MODEL BENTLEY MARK VI

STONE GUARDS ON REAR WINGS AND SILL.

Bulletin

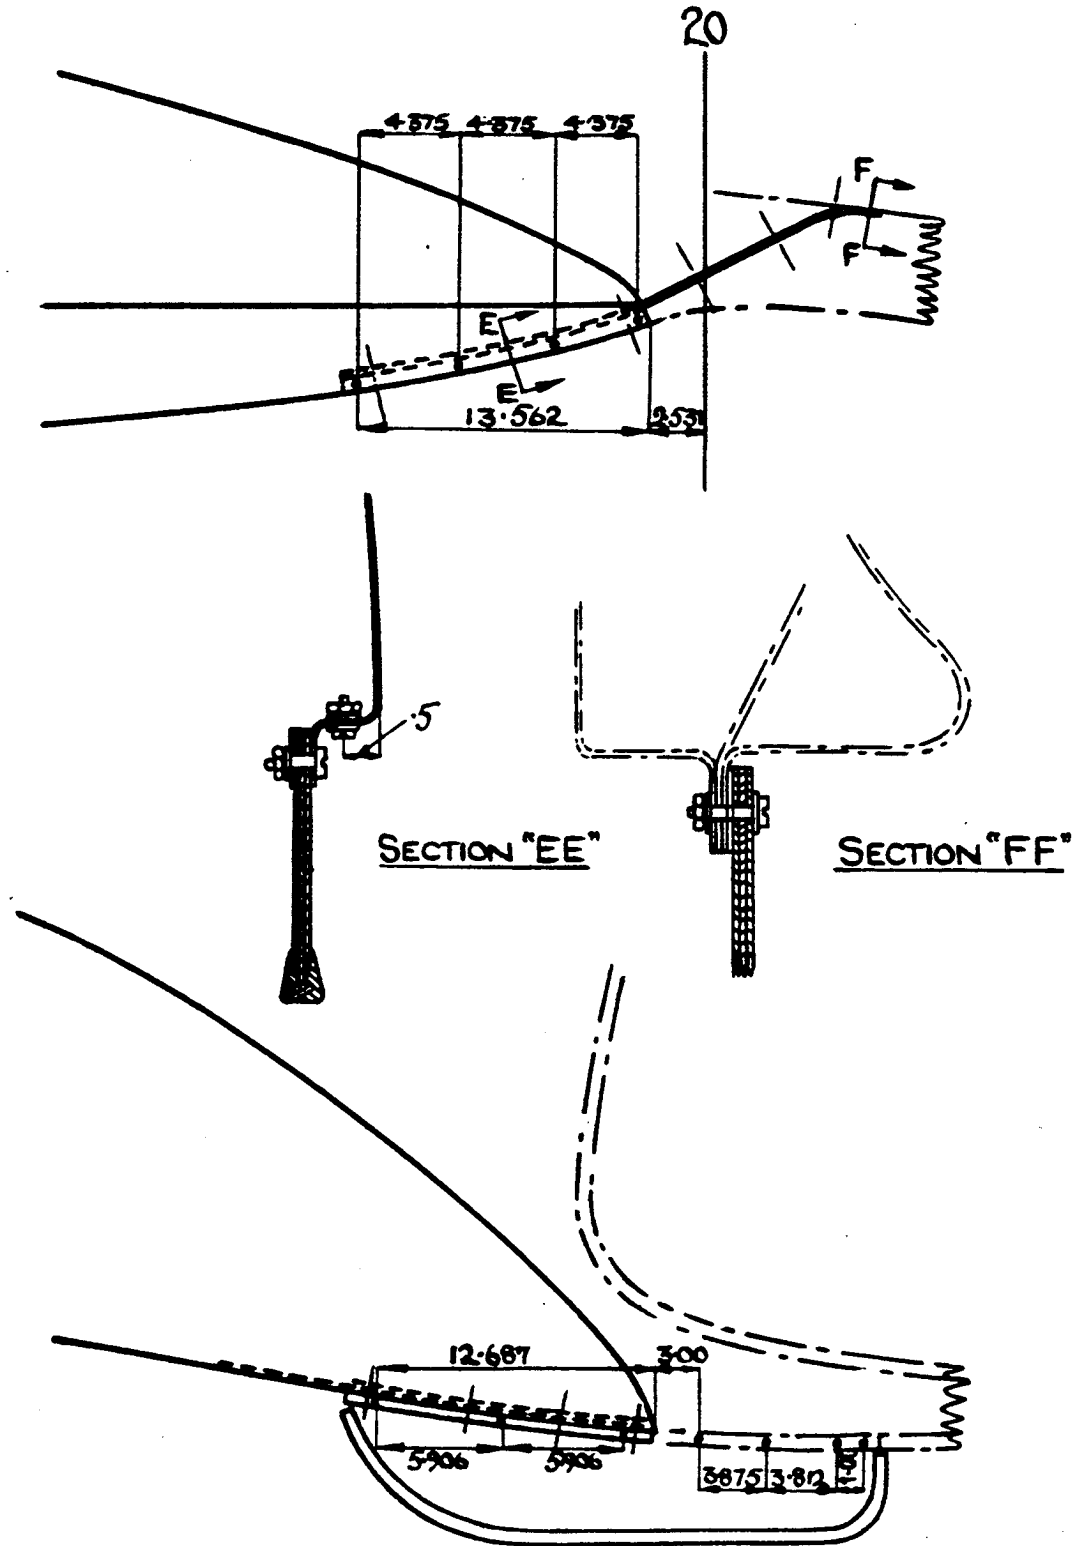
MODIFICATION.FRONT WING MUD FLAPS.

Front wing mud flaps are now fitted to all cars being manufactured with Bentley standard coachwork.

The mud flaps are fitted to the rear underside of the front wings, the method of attachment being by angle plates and 2-BA bolts and nuts, the positioning of these may be noted from the attached drawing.

Section through rubber seal, showing correct methods of sticking seal in position.

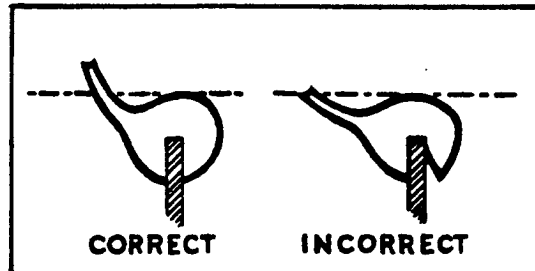
- (iv) Stick the new rubber sealing strip in position with Bostik or other suitable waterproof adhesive. This operation will have to be very carefully carried out, as it is possible to stick the rubber in position in such a way that the lip is level with the main body of the seal instead of sticking up above it. (See illustration)

Also, before allowing the adhesive to set, make sure that the rubber is so positioned that it will contact the lip of the ventilator all the way round. This can easily be checked by placing the ventilator in position and then trying to rock it.

- A. STATIONARY BRACKET.
- B. ADJUSTABLE SPINDLE.
- C. THACKERY WASHER.
- D. BRASS SLIPPING WASHER.
- E. NUT FOR SPINDLE
- F. LOCK NUT.

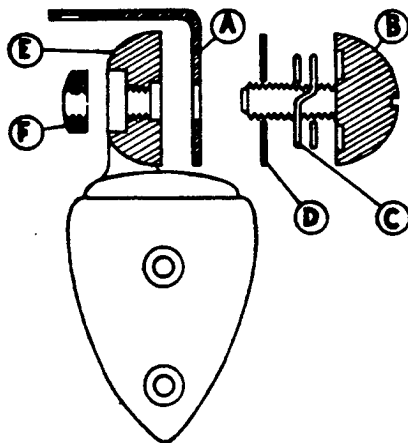
1. With the lock nut (F) loose, screw in B as far as it will go. This should completely lock the assembly.
2. To obtain the correct amount of friction, unscrew B slightly, the precise amount can be determined by testing the movement of the vizor, but it will be approximately $\frac{1}{4}$ turn. Tighten the lock nut with a forked screwdriver as tightly as possible.
3. Increase the locking action by further unscrewing B very slightly, at the same time turning the lock nut with it. The friction of the bolt and nut thread is thus used to help the lock nut to tighten up an extra fraction of a turn against E.

The brass washer D may not always be found on early chassis Nos. and if this is the case, a similar washer should be fitted about .025" thick. This prevents the end of the Thackery washer C from biting into the bracket.

NEW SEAL LYING SIDWAYS AS APPLIED TO TRUNK DOOR, EDGE 'D'

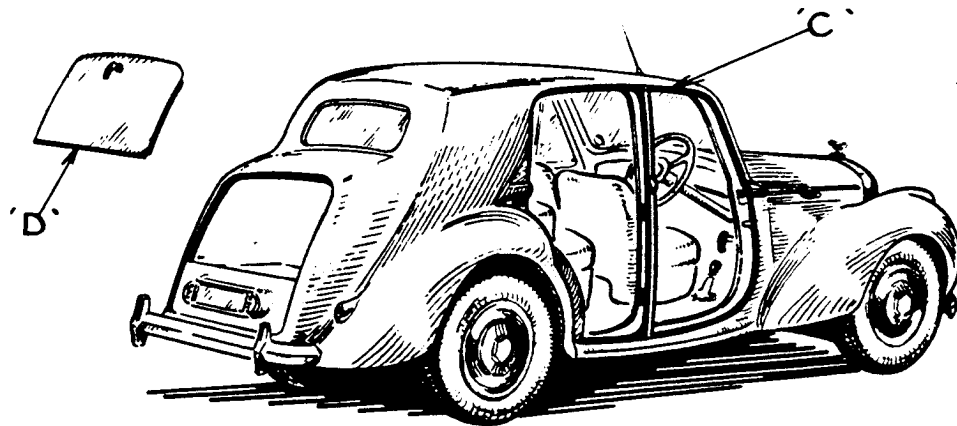
The new seal is a very soft, white, sponge rubber, roughly triangular in section, as shown at 'A' on the diagram and the apex of the triangle forms the contact point for the door, except in the special instance of the trunk door (see later). Owing to its spongy nature, the rubber is very susceptible to oil or grease.

The lower edge of the trunk door (D) which makes a joint with the upper edge of the spare wheel compartment lid requires the special treatment shown on the diagram whereby the rubber is applied lying sideways, as there is insufficient room for the rubber to be applied normally if the spare wheel compartment lid is to shut properly.

Although the new rubber has greater flexibility than the old (B), it may be necessary to adjust the door striker plates to obtain good matching of the doors with the body shell and a good door shutting action.

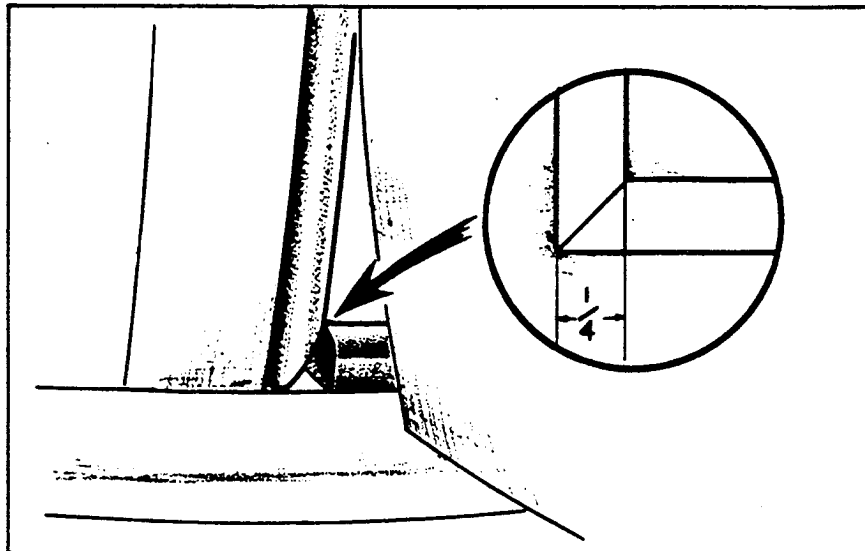
Cases have occurred in wet weather where drain water from the doors has "built-up" on top of the lower door sills of Standard Saloons.

Investigations have shown, that in all these cases, the cars concerned were fitted with the later type soft sponge, triangular section door sealing rubbers, and that the natural tendency for this sponge rubber to spread rendered it impossible for the waste water to drain away while the doors were closed.

In order to compensate for this tendency to spread, and at the same time provide adequate means for drainage during wet weather, all current Standard Saloons in production have the bottom sealing rubber along the outer edges of the sills "cut back", leaving a gap of approximately $\frac{1}{4}$ " at the point of juncture with the vertical sealing strip at the foot of the centre door pillars as shown in the attached sketch.

MODIFIED ASSEMBLY.

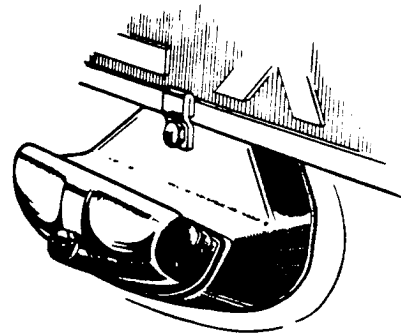
In order that all Bentley Mark VI cars now operating in the U.S.A. shall conform with existing lighting regulations, a modified type of rear number plate support bracket has been introduced, which, when used in conjunction with the existing lamp, will provide direct illumination of the rear number plate.

This modified support bracket differs from the standard fitting by having a built-up boss, the outer face of which is set at an angle of 28° relative to the bracket itself. The lamp is fixed to this inclined face, thus ensuring that the number plate is directly lit.

Fig. 1.

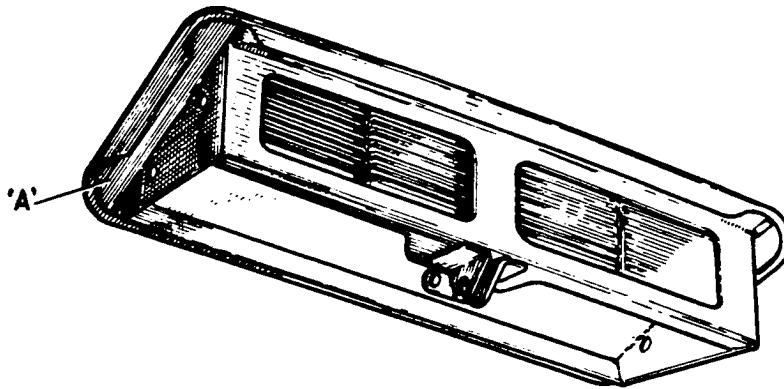
In the event of a complaint from a customer of insufficient ventilation through the top scuttle ventilator, a modification has been introduced as described below for improving the air flow, by removing the existing two grilles from the scuttle ventilator lid and fitting a nickel plated wire mesh screen. (Part No. RB.5266 - obtainable from the London Service Station.)

- (i) Remove the scuttle ventilator lid by unscrewing two screws on each end and removing the pin or bolt from the lower end of the link attached to the lid.
- (ii) Remove the two grilles, (shown in Fig.1) starting from the outer ends by drilling into the spot welds on the inside. The inner ends can then be easily removed with a small chisel.
- (iii) With a pair of shears or a hack-saw open out the two intake holes and file to the dimensions shown in Fig. 2. leaving the double thickness of metal down the central division.
- (iv) Solder the wire mesh screen in position so that it covers the whole of the inside face of the intakes.

Fig. 2.

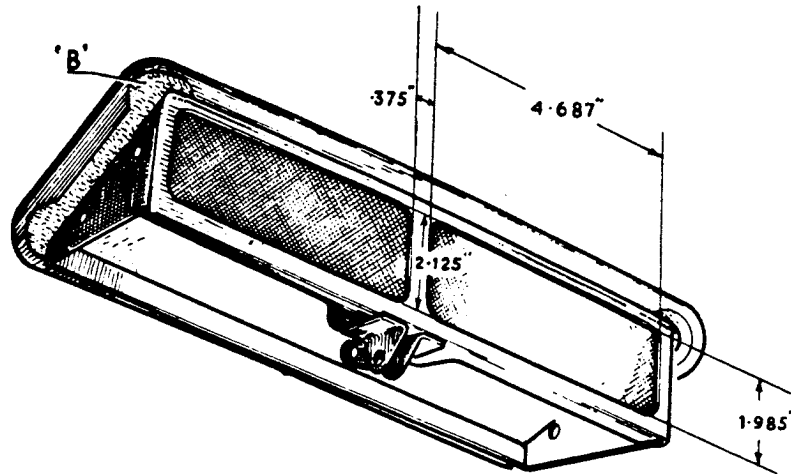
- (a) Thoroughly clean the underside of the lid and fill in the depression at each corner with solder to surface level, ('B', Fig. 2). Also fill in the channel running along the two sides, which lead into each corner. Face off the solder as necessary until it is flush all the way round.
- (b) Mask the wire screen and re-cellulose the lid taking care to match the colour. Do NOT cellulose the wire screen.
Note: The above method of filling-in, which is preferable to the method described below, should however, only be undertaken where it is possible to match the existing colour, because, owing to the blistering effect of the solder it will be necessary to entirely re-cellulose the lid.
